July 27, 2023,  
Via Electronic Filing

Re: Docket LC 80: Energy Advocates' Round 1 Comments on Portland General Electric's Clean Energy Plan and Integrated Resource Plan

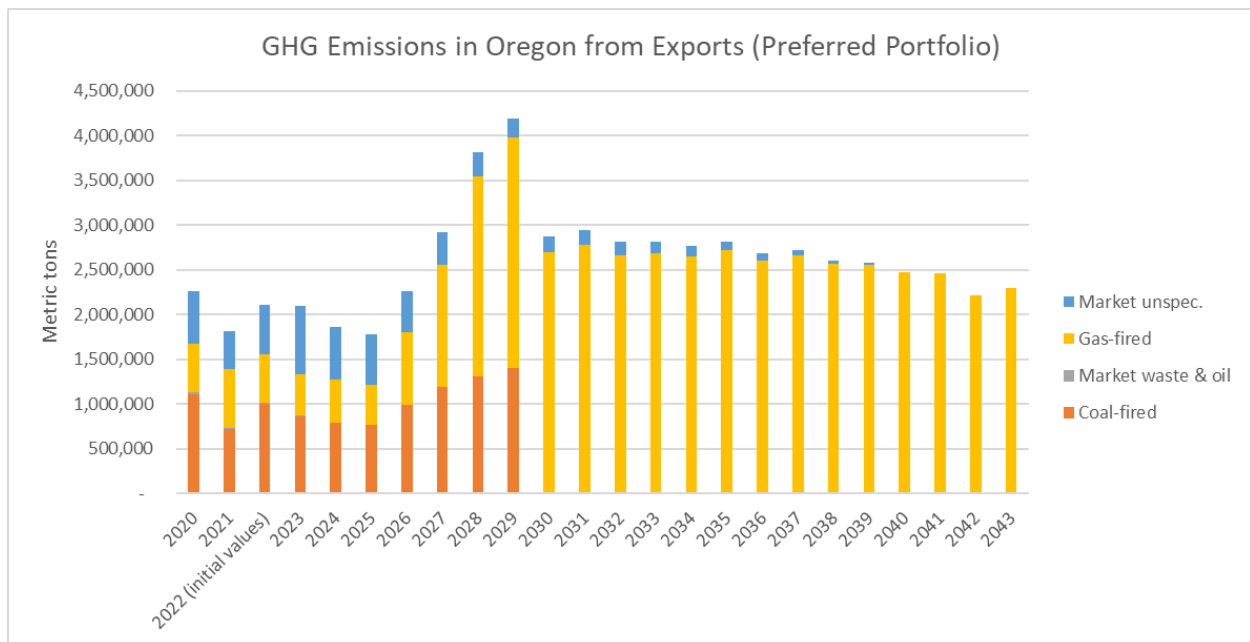
Furthermore, PGE claims to be transparent regarding the generation (and emissions) from existing thermal facilities for wholesale sales. They provided data showing the retail/wholesale allocations via the Clean Energy Plan Data Template in the IRP/CEP Addendum. That data for the Preferred Portfolio is shown in the figure below, which shows a level of GHG emissions from exports growing from 2 million Mt/yr to over 4 million Mt/yr in 2029 and a relatively steady 2.5 million Mt/yr after 2030. The major growth comes from gas-fired generation, while the drop is due to the closing of Colstrip. Energy Advocates consider this level of continuing emission in Oregon to be unacceptable and not consistent with Oregon overall GHG reduction targets. Seeing this level of emissions further reinforces our position that PGE’s economic dispatch calculation should consider the costs for health and social impacts to Oregonians near these
